PC 24-05

Amend approvals previously granted for the subject property to allow construction of a two-story multi-tenant commercial building with drive-through; approval of a plat of subdivision.

Anna Papke, AICP
 Planning and Zoning Manager

SUBJECT: Site Plan Evaluation
Proposed Creekside Plaza
Lombard, Illinois

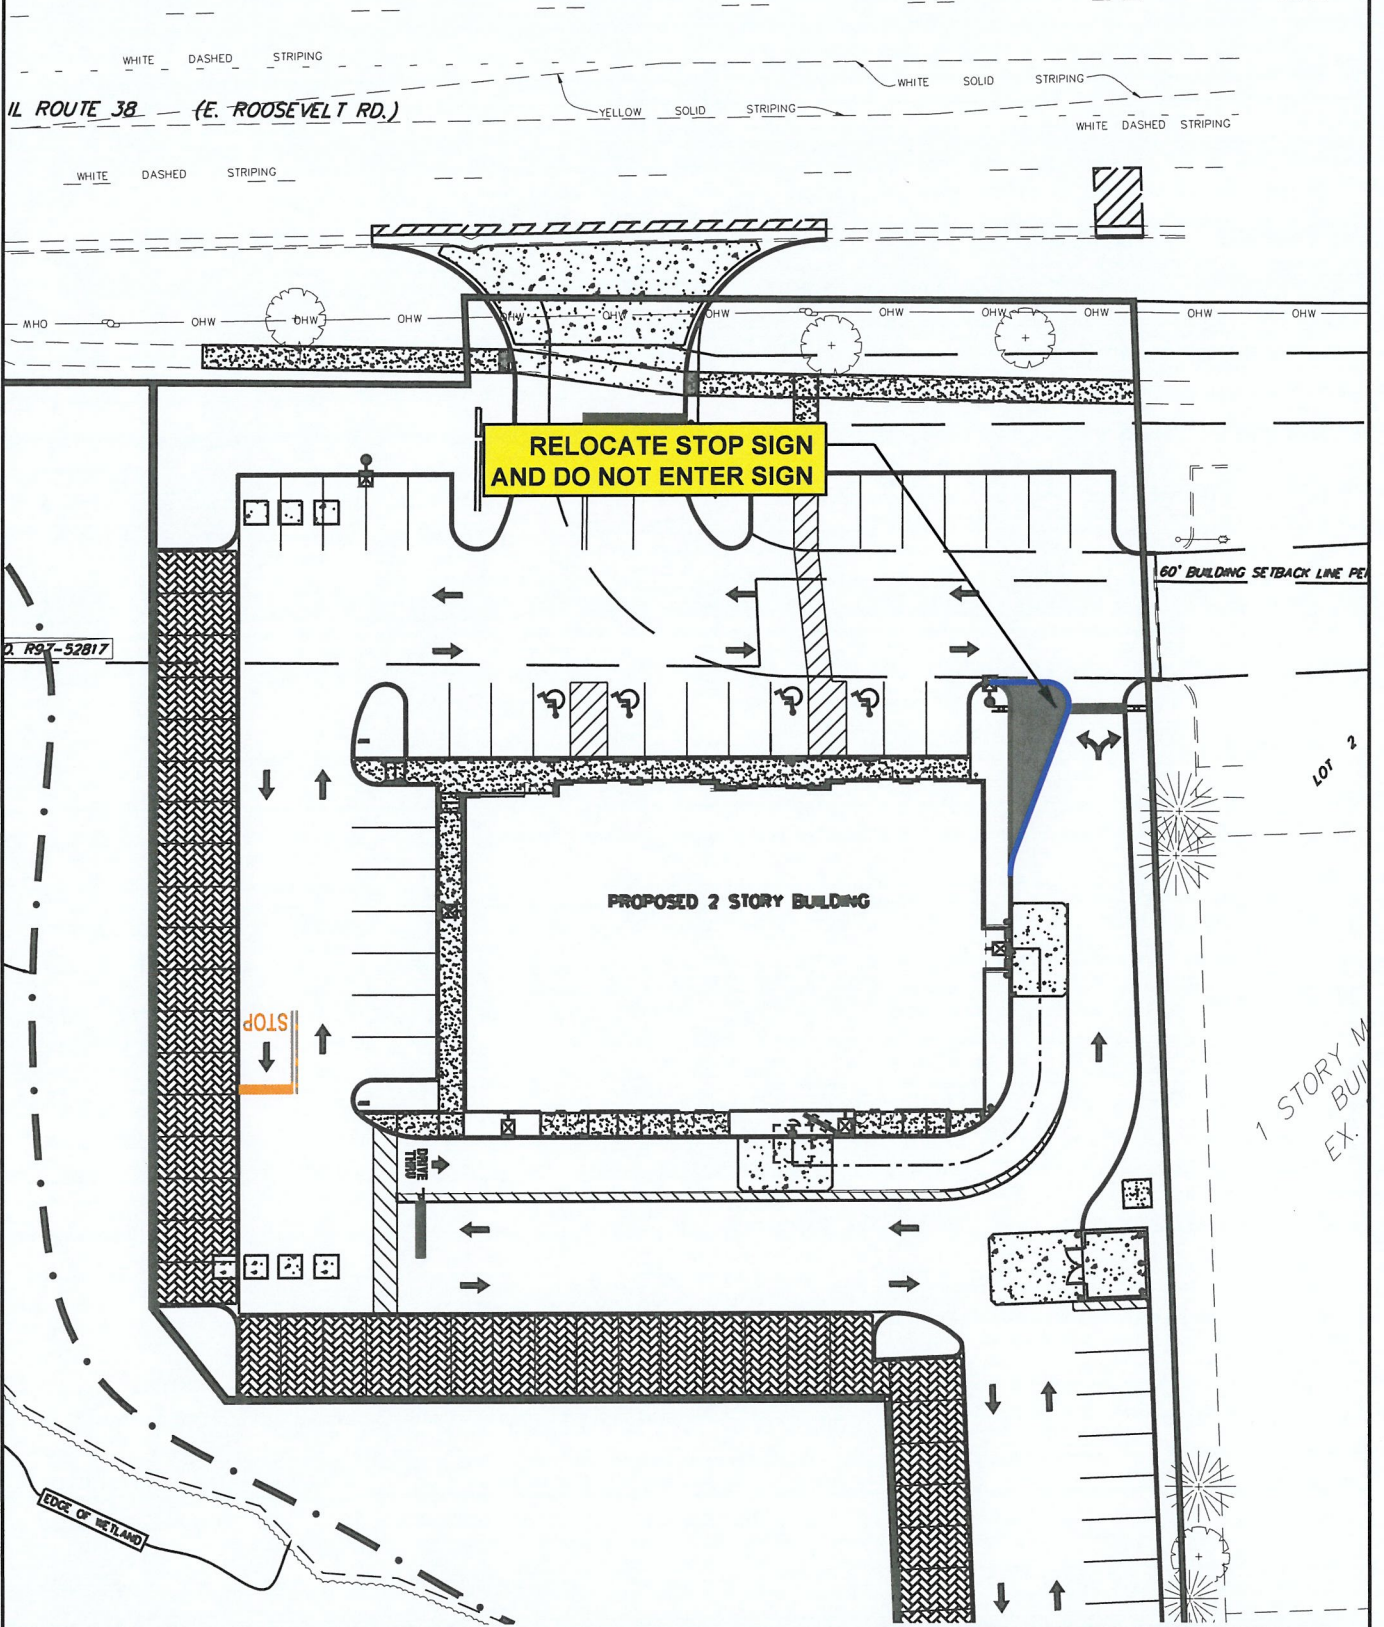
The development as proposed will provide, at a minimum, 24-foot-wide drive aisles within the parking lot, allowing for efficient circulation. Based on a review of the site plan, the southern drive aisle will run parallel with the drive-through lane. In order to control and organize the turning movements that will occur on the southwest corner of the building, it is recommended that a stop bar be painted on the western drive aisle for southbound traffic. This stop bar should be located approximately 12 to 14 feet north of the drive-through lane entrance. Further inspection of the site plan indicates that the east side of the building will have two northbound lanes intersecting the northern east-west drive aisle. One lane will be the exit lane of the drive-through facility while the other lane will be the by-pass lane. This exiting drive from the facility should be narrowed down to one lane in order to control the exit flow and provide a better radius/curvature for vehicles desiring to turn left and exit via the full access drive. The outbound movement should be under stop sign control and a "Do Not Enter" sign should be posted on the exit drive facing north. Exhibit A in the Appendix illustrates the recommended modifications.

- The two exiting lanes on the east side of the building should be narrowed down to one lane in order to control the exit flow and provide a better radius/curvature for vehicles desiring to turn left and exit via the full access drive.
